REV. DETAILS
B
A
Basement amendments due to Council's R.F.I.
Section 4.56 Modification Application

PROJECT ADDRESS
**78, 80 & 84 Bursill St,
Guildford, NSW, 2161**
PROJECT NO. STATUS
17/14 S.96
DRAWN BY CHECKED BY

DRAWING:
Basement Floor Plan
SCALE: 1:100@A1
1:200@A3
DRAWING NO.: **A2.2**
ISSUE: **B**
Copyright Mackenzie Architects International. All rights reserved

Second Floor Plan

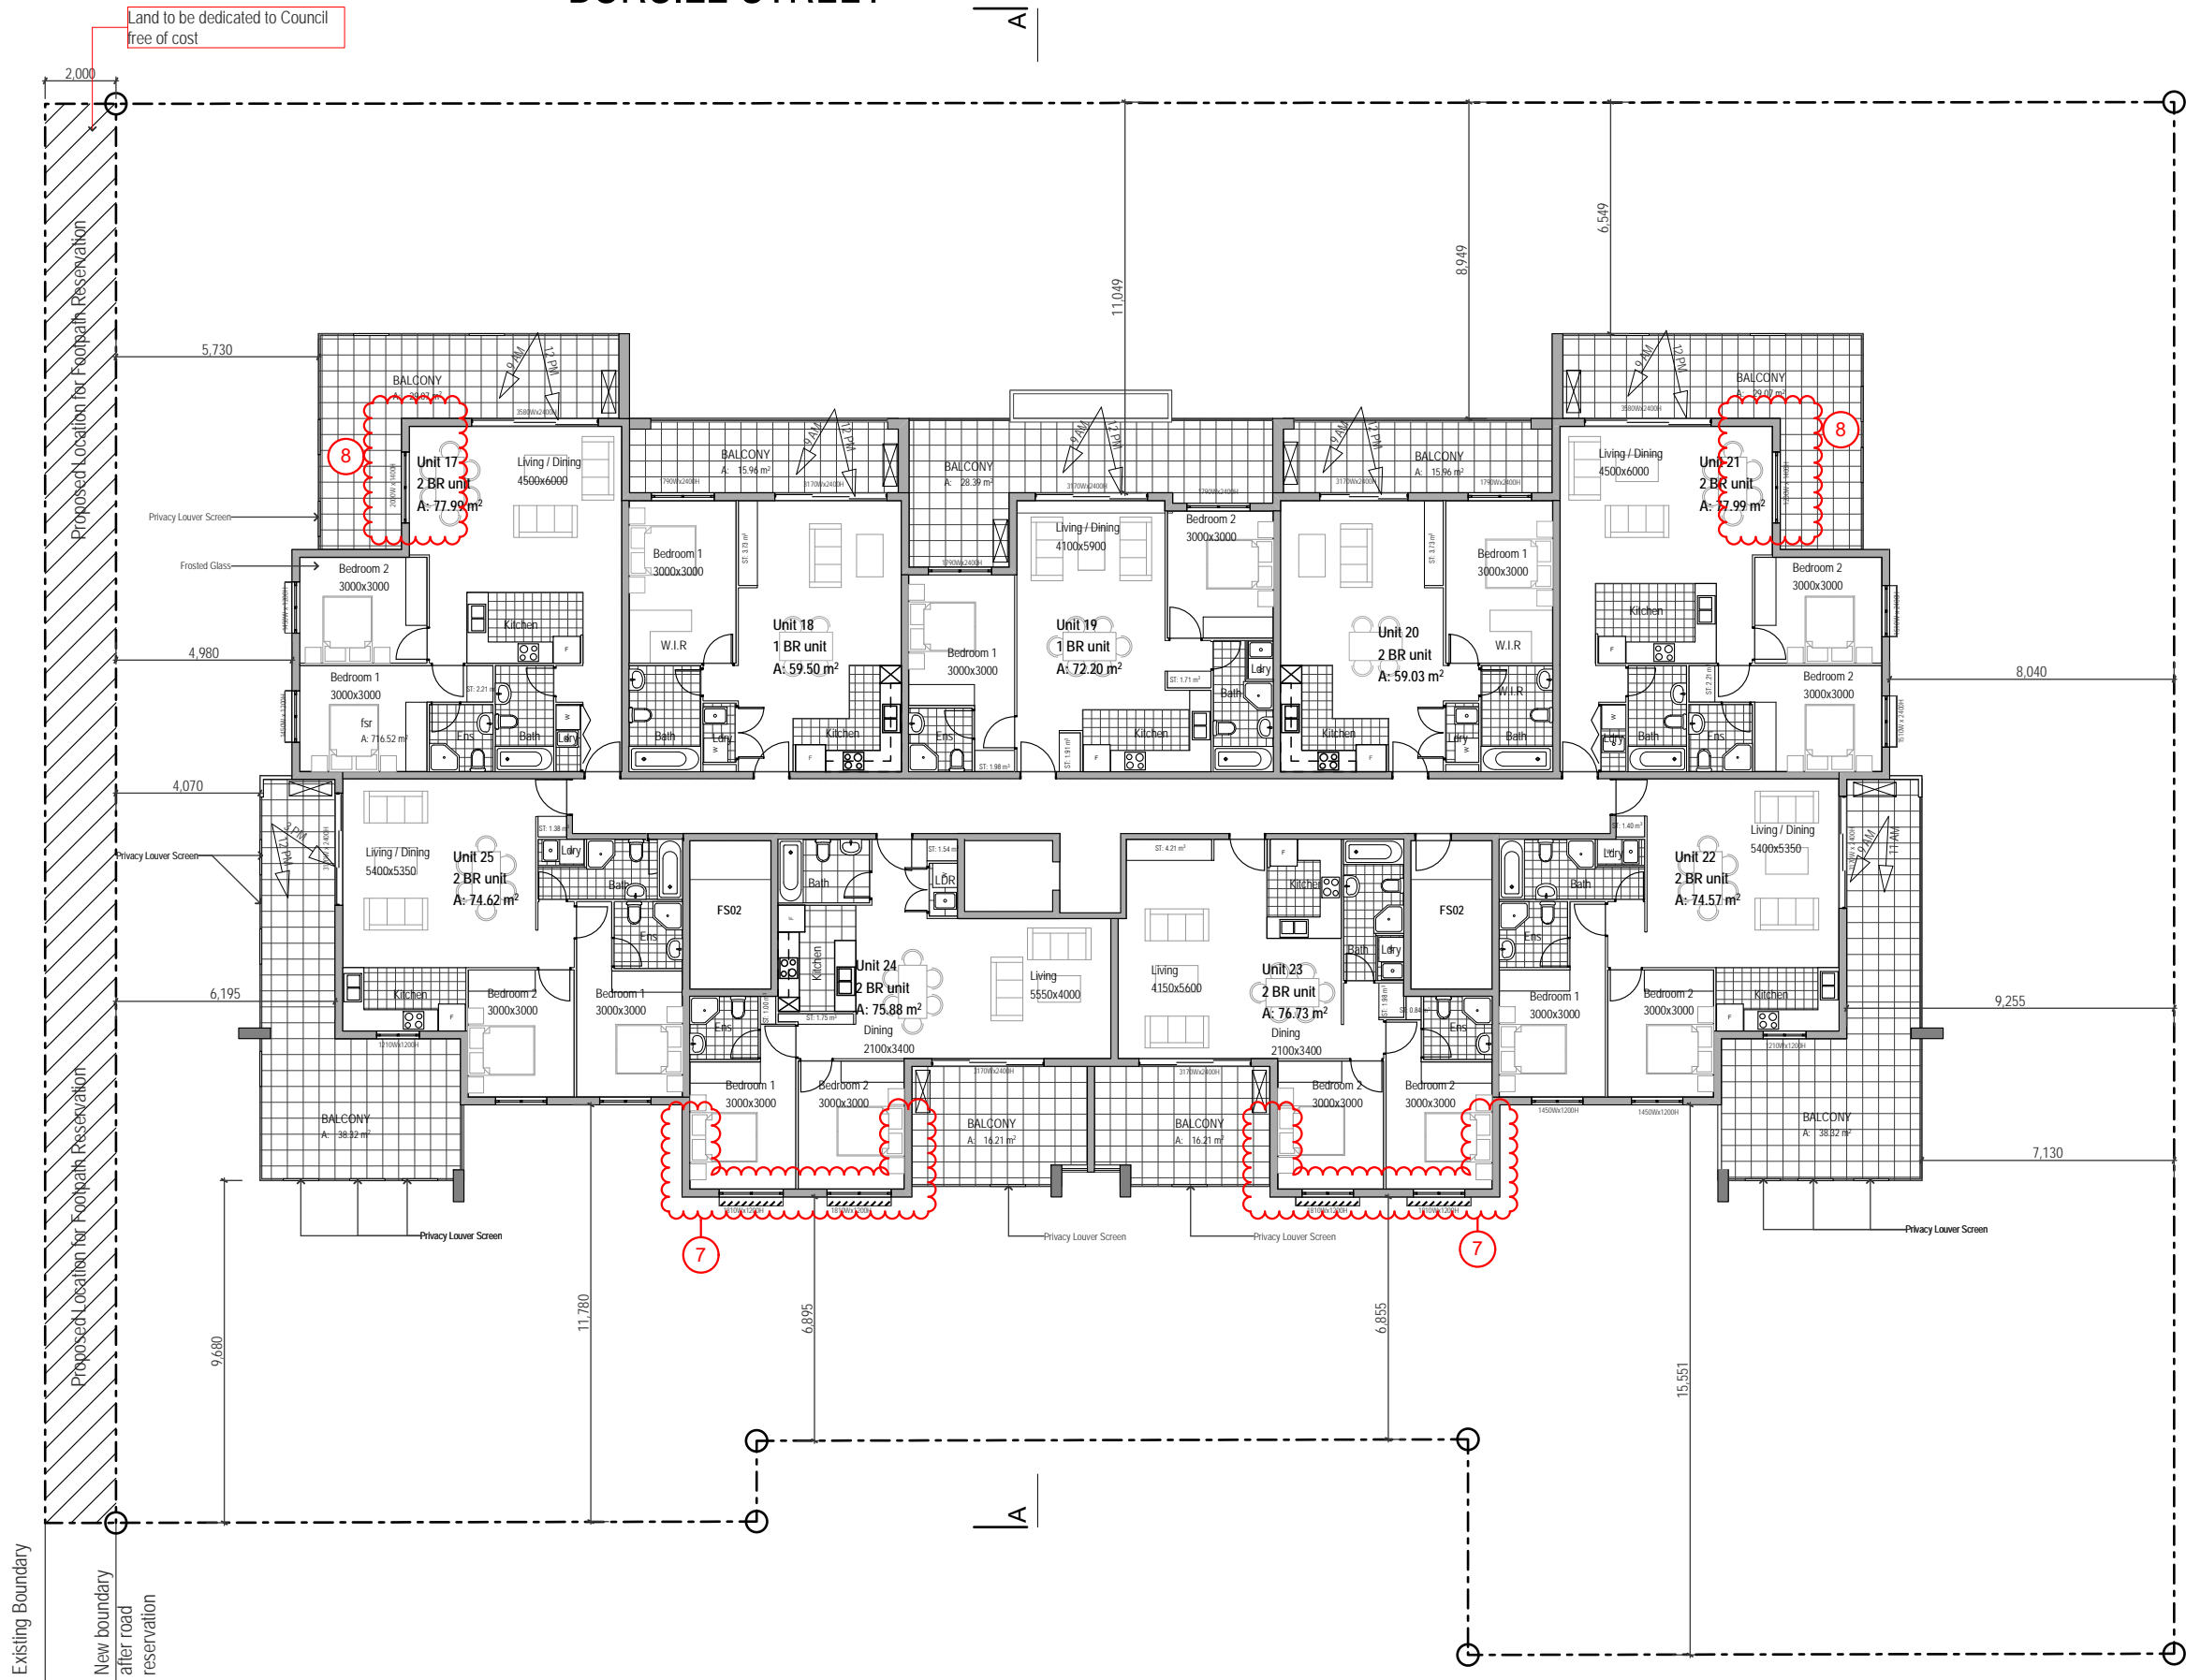
AMENDMENTS:

BASEMENT:

1. - STORMWATER O.S.D. CONCEPT AMENDED;
2. - SERVICE ROOMS IN S.W. CORNER ADDED;
3. - SOUTH FIRE STAIR REMOVED;
4. - STORAGE, LIFT + CIRCULATION AMENDED: BASEMENT NOW ONE LEVEL;

GROUND:

5. - BIN STORE AMENDED;
6. - DELETE WINDOW, SQUARE OFF BUILDING CORNER;

FIRST; SECOND; THIRD:

7. - DELETE BEDROOM 1 WINDOW, MOVE BEDROOM 2 WINDOW, SQUARE OFF BUILDING CORNER;

SECOND; THIRD:

8. - CONSOLIDATE WINDOWS INTO ONE WINDOW;

DRAWING:
North and South Elevations

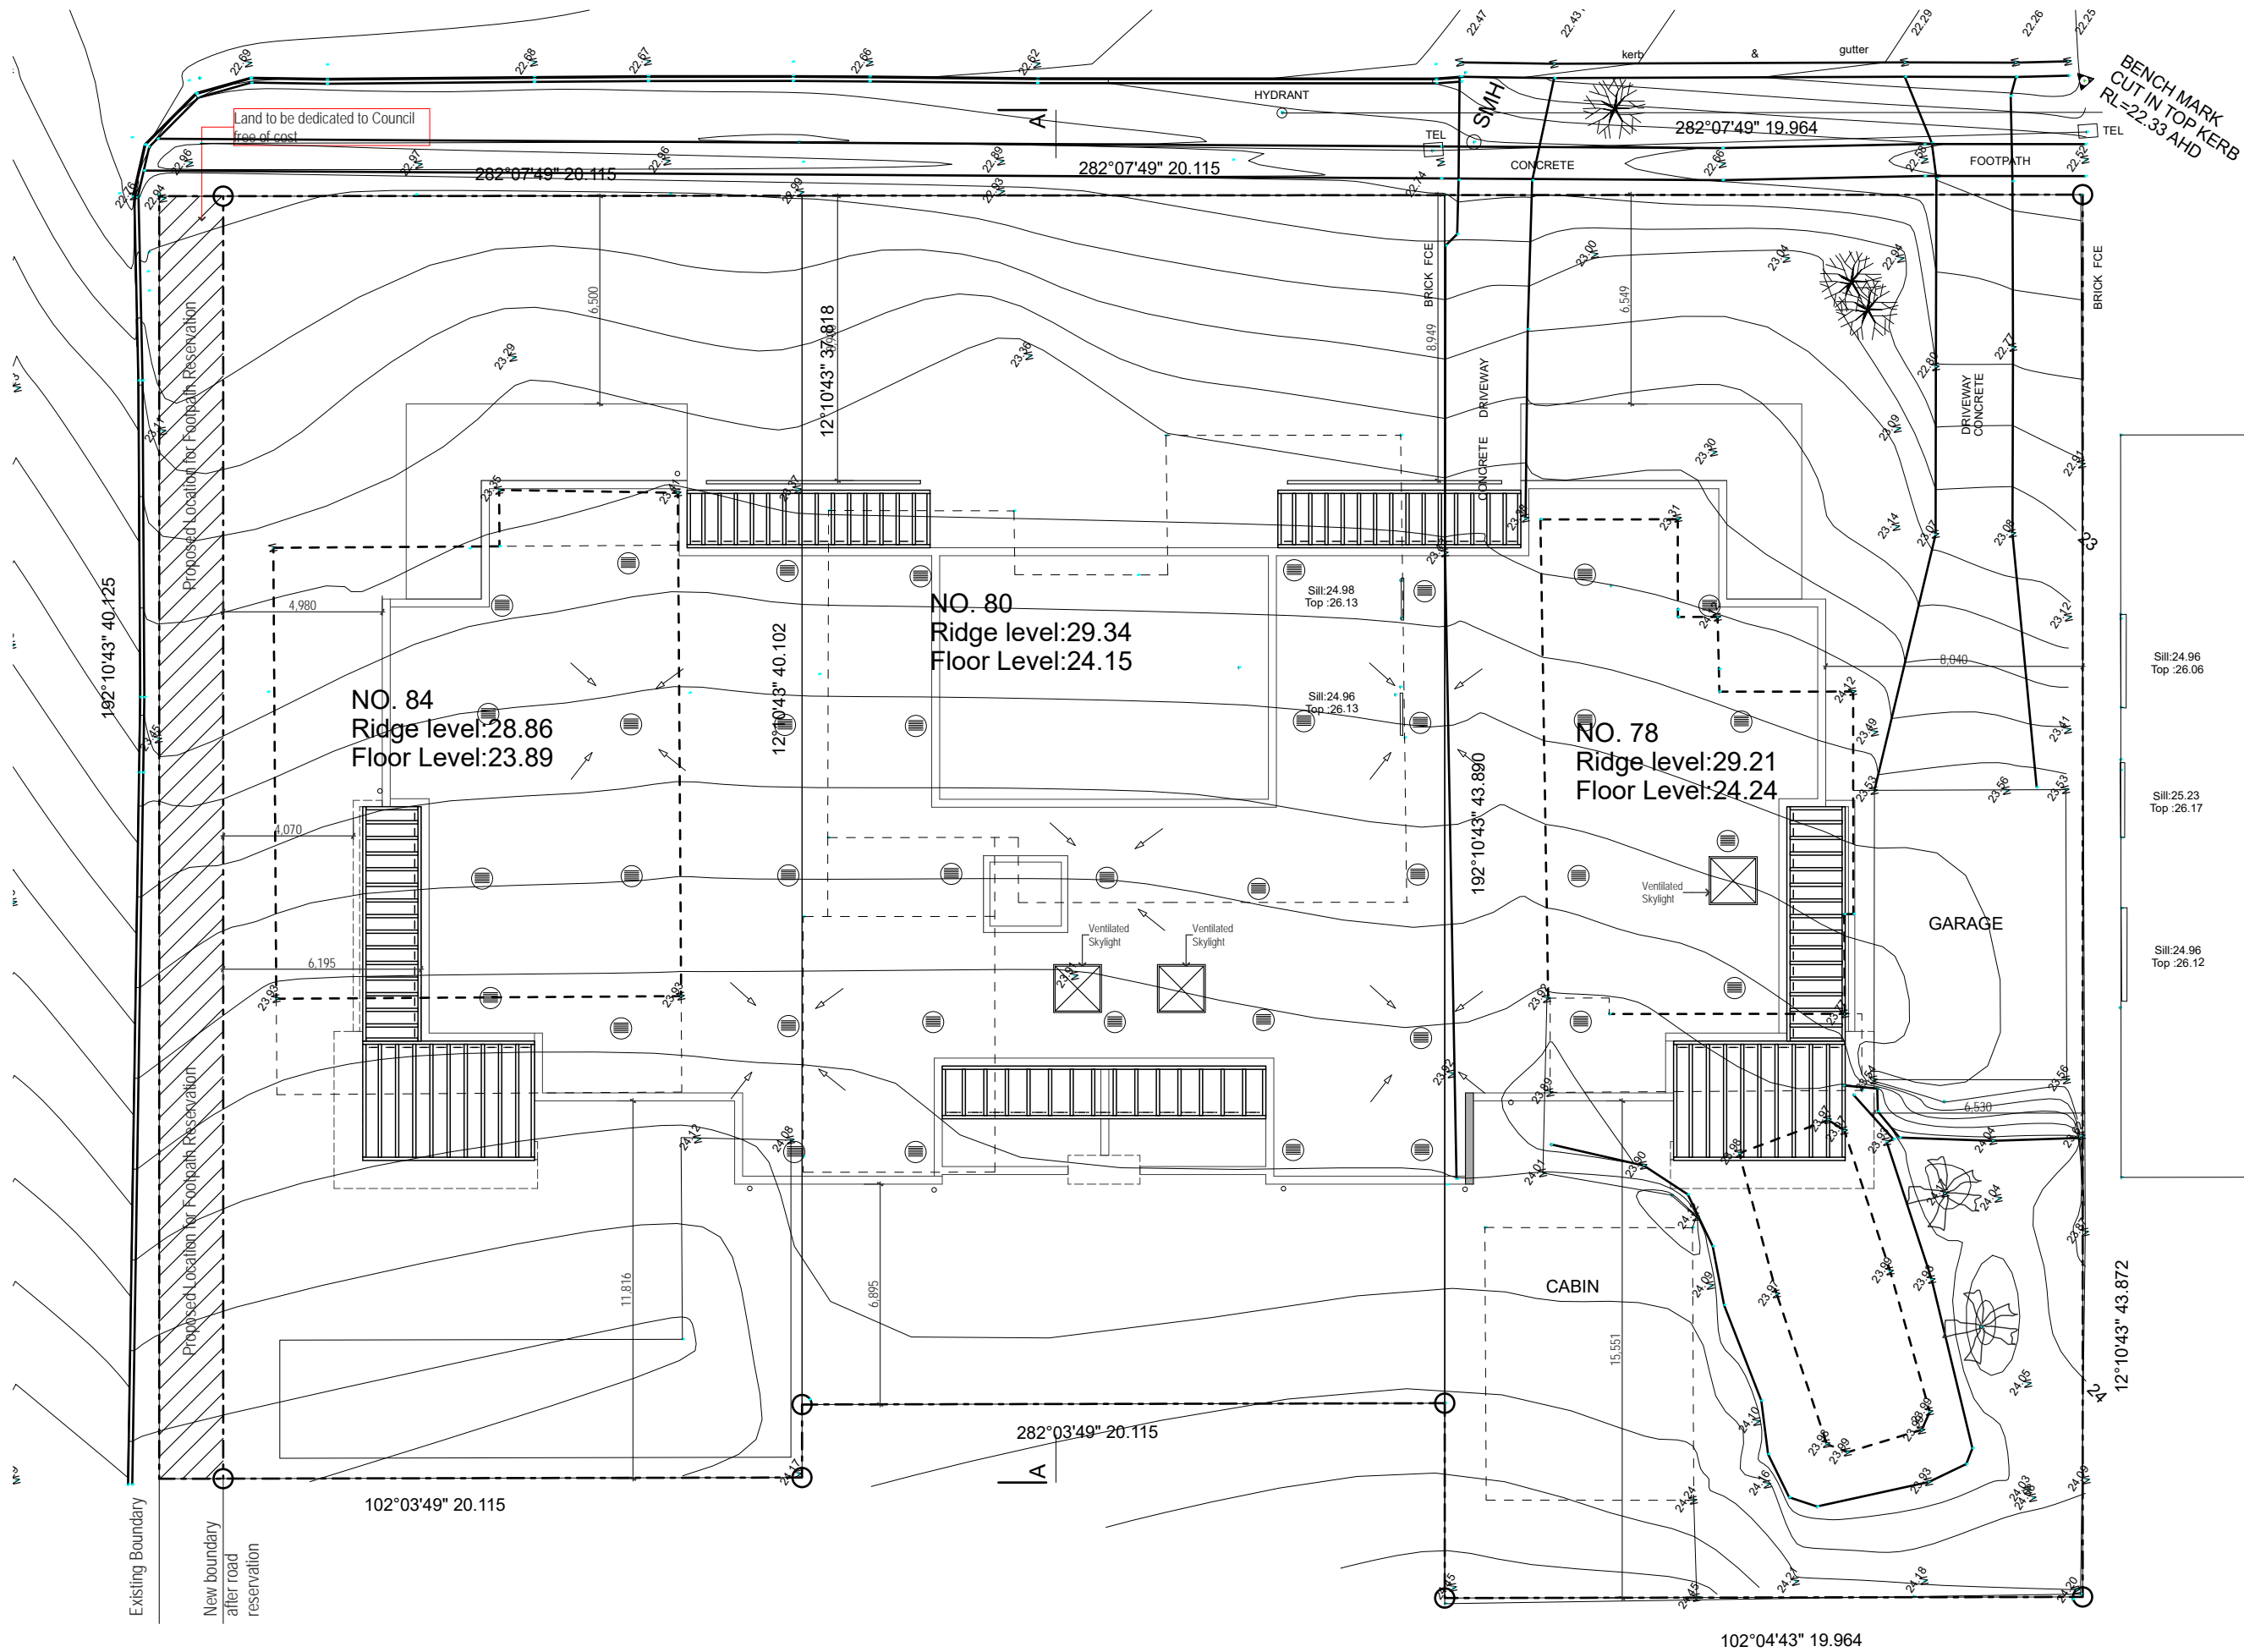
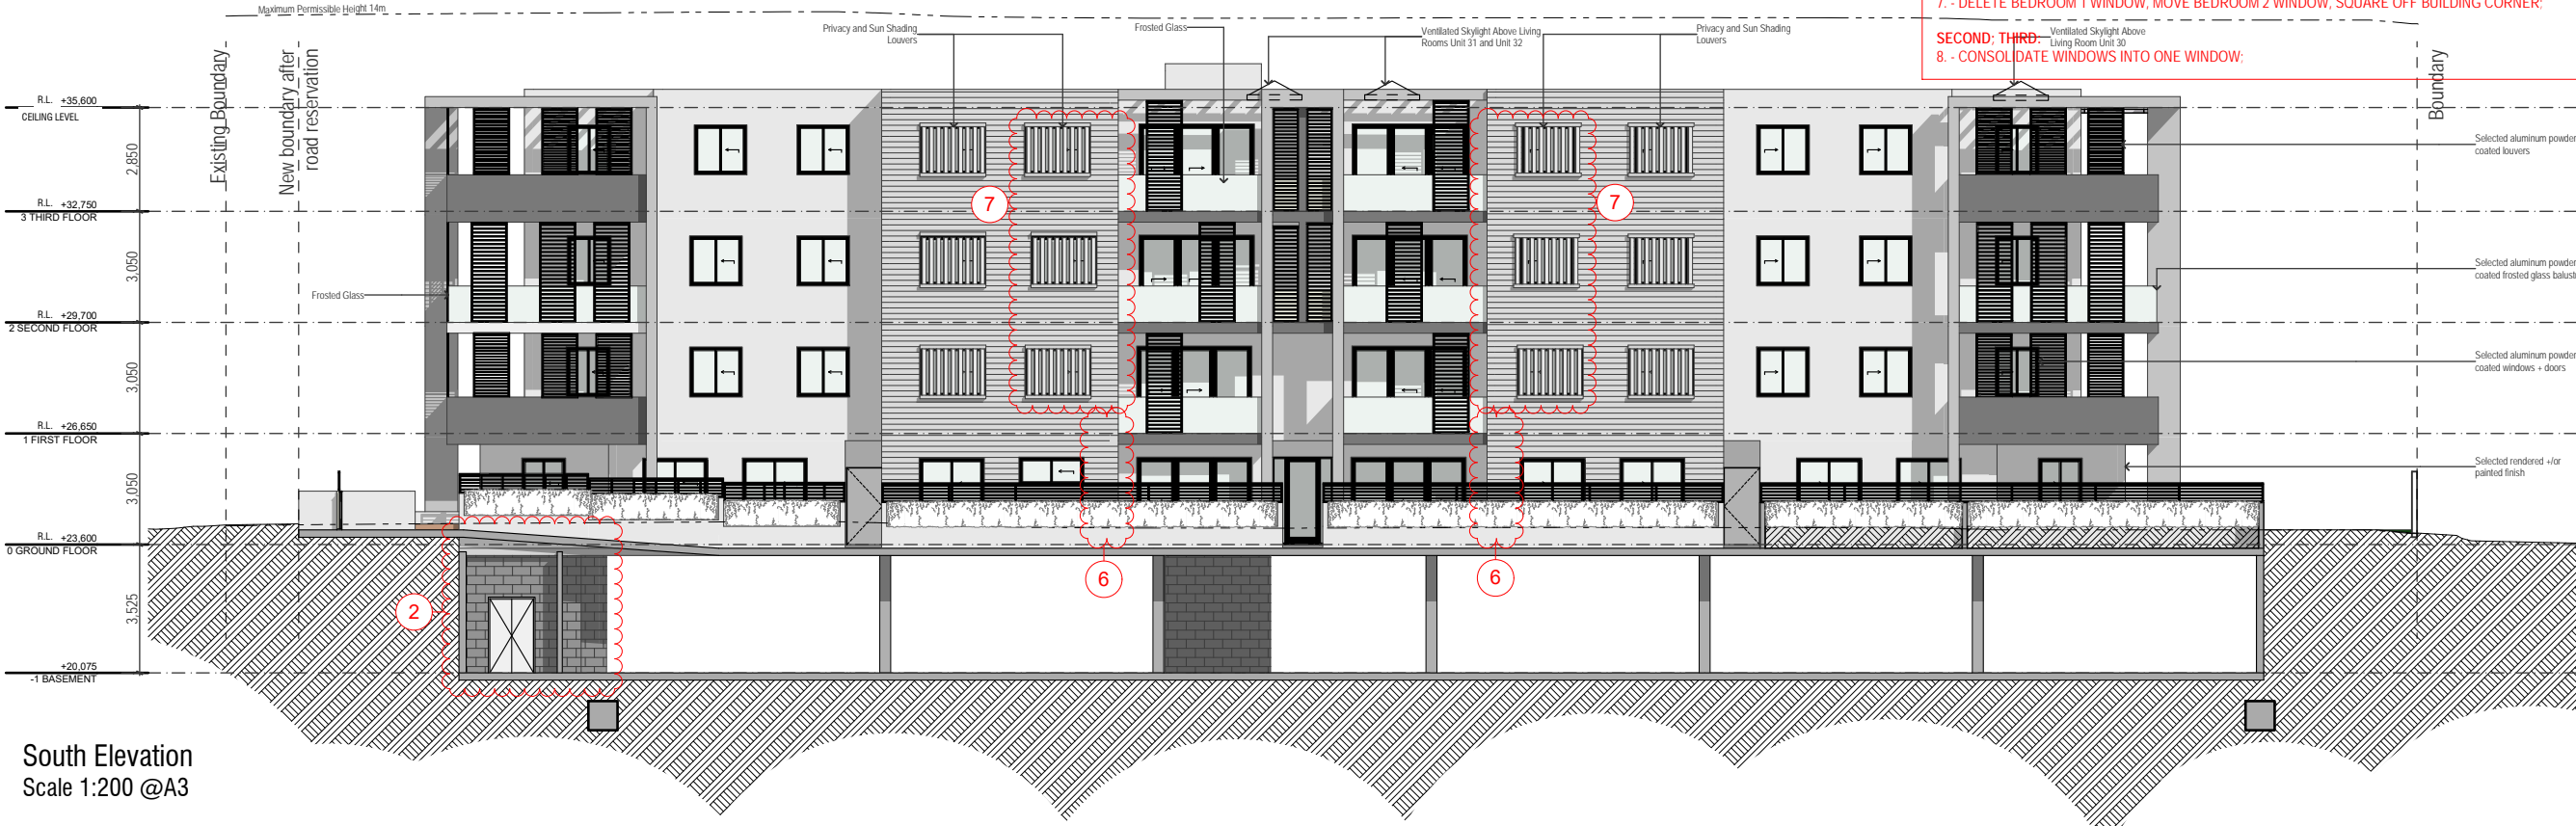
AMENDMENTS:
BASEMENT:
1. - STORMWATER O.S.D. CONCEPT AMENDED;
2. - SERVICE ROOMS IN S.W. CORNER ADDED;
3. - SOUTH FIRE STAIR REMOVED;
4. - STORAGE, LIFT + CIRCULATION AMENDED; BASEMENT NOW ONE LEVEL;
GROUND:
5. - BIN STORE AMENDED;
6. - DELETE WINDOW, SQUARE OFF BUILDING CORNER;
FIRST; SECOND; THIRD:
7. - DELETE BEDROOM 1 WINDOW, MOVE BEDROOM 2 WINDOW, SQUARE OFF BUILDING CORNER;
SECOND; THIRD:
8. - CONSOLIDATE WINDOWS INTO ONE WINDOW;
